**RFB-2022-42**  
**SCCC CHEMISTRY LAB RENOVATION**

**ADDENDUM #2**

Issued Date 3/2/2022

Bench #3 and Bench #4

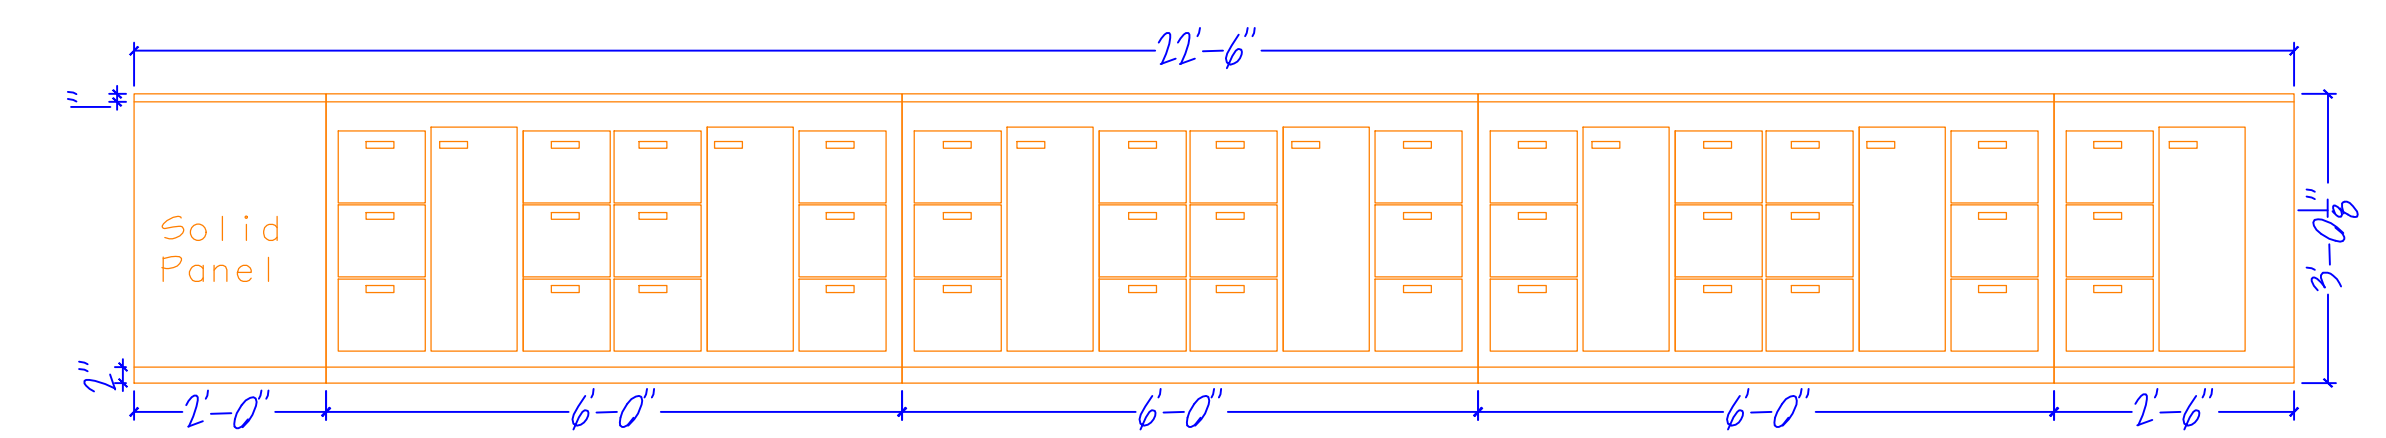
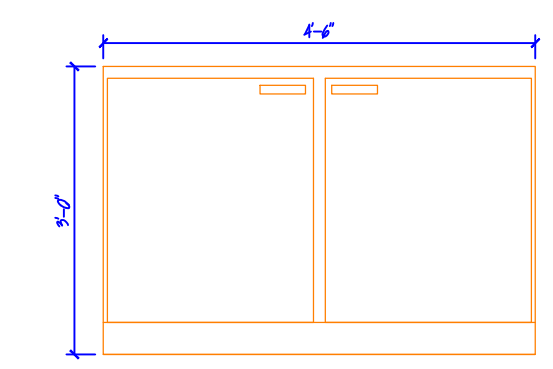
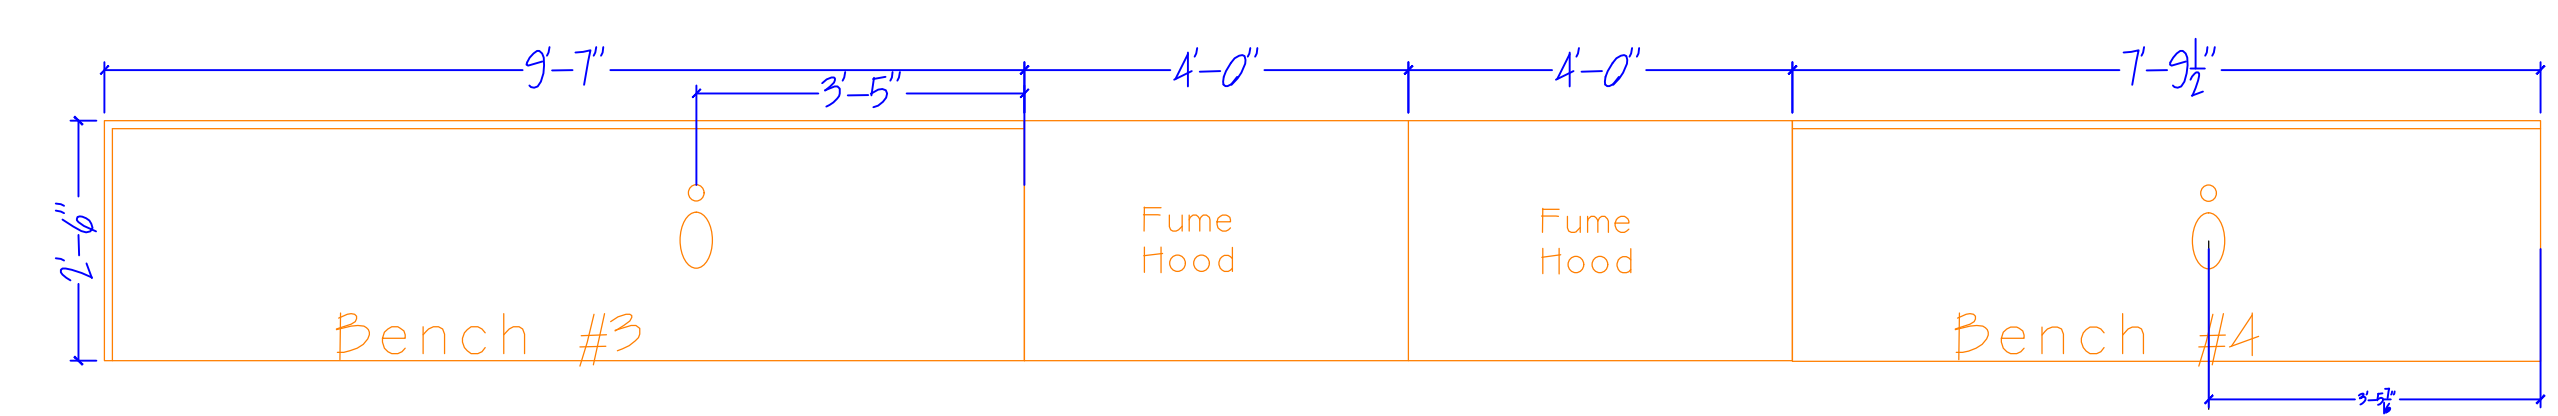
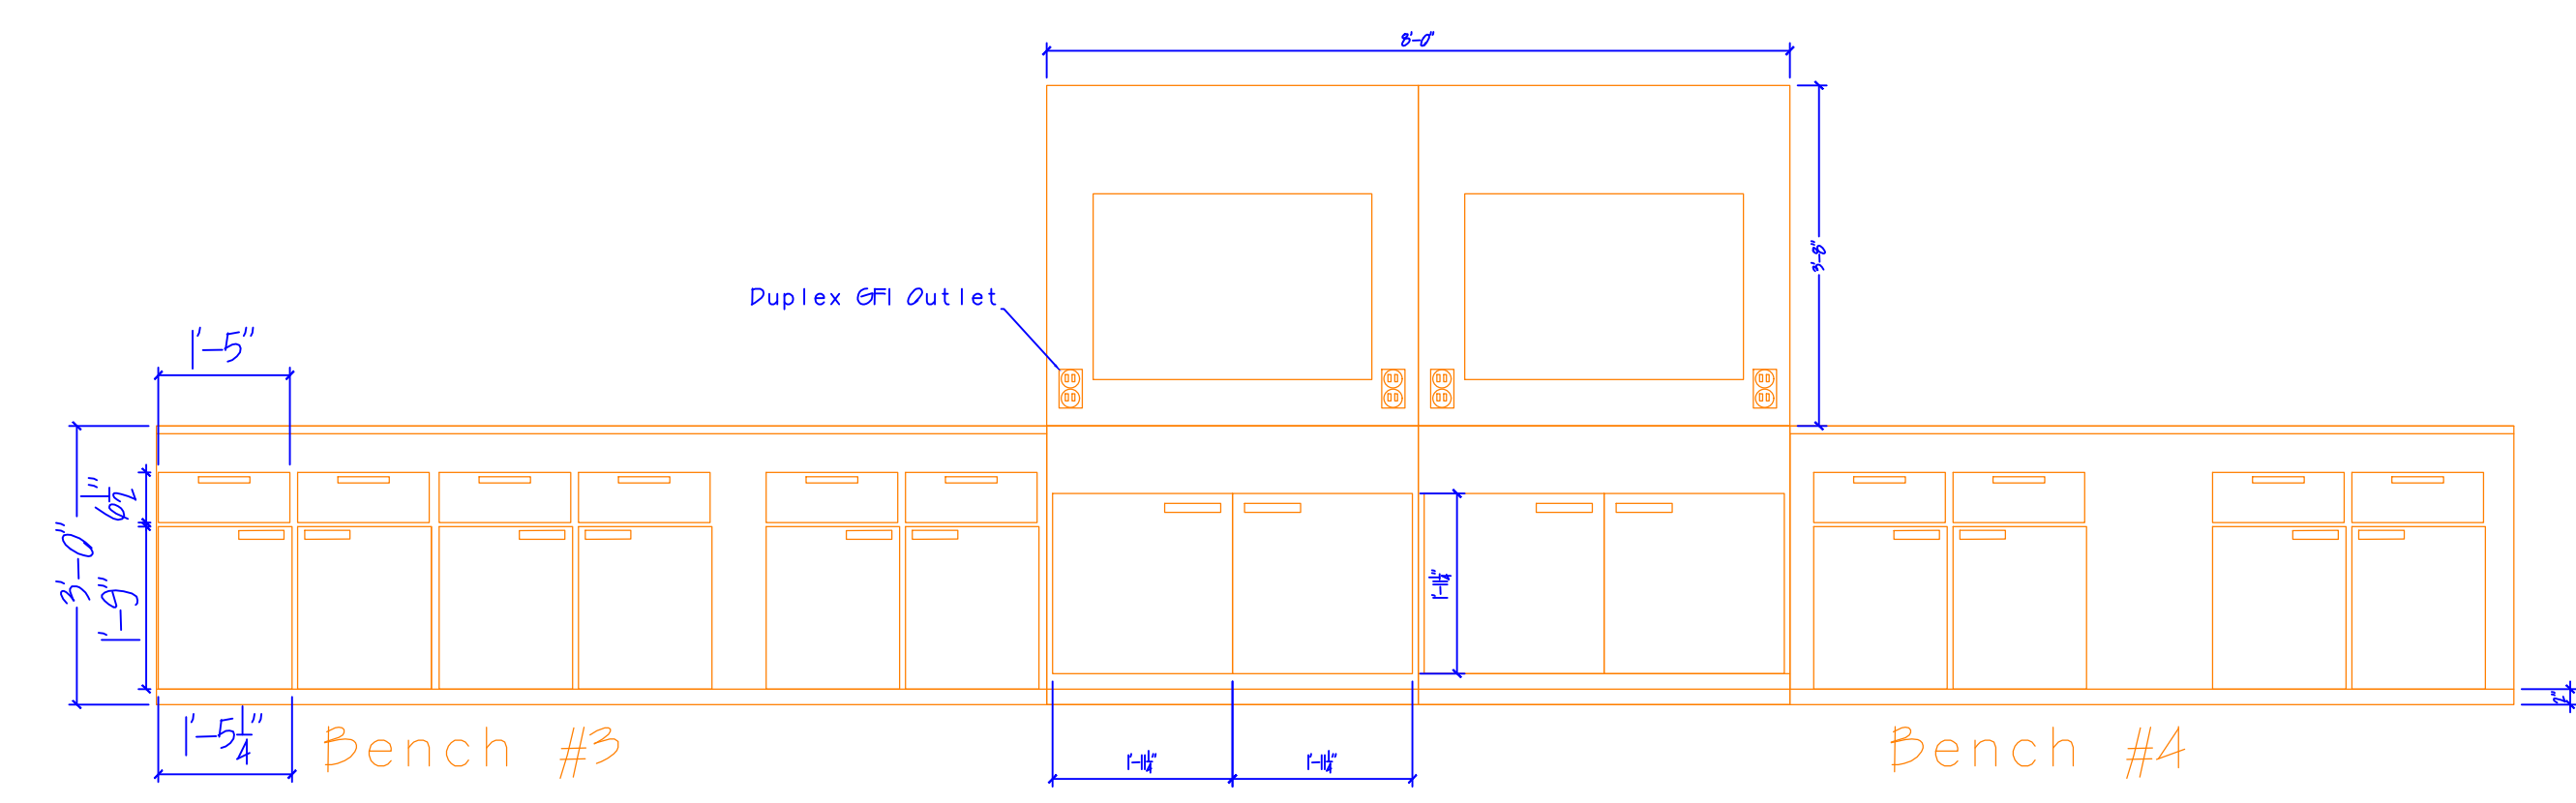
1. Areas to quote in Chem Lab 202: Bench #1, Bench #2, and Teacher Station, were identified in the A-2 Cabinet Details and Existing Condition Images, however it appears a Bench #3A & Bench 3B, on left & right sides of the 2 Fume Hoods on the back wall may not have been identified as well as a Bench #4 at the end of Bench #1. Please outline those pieces as well as anything else that needs to be included in the bid for room Chem Lab 202.

Answer: [Please see revised drawings attached to this addenda.](#)
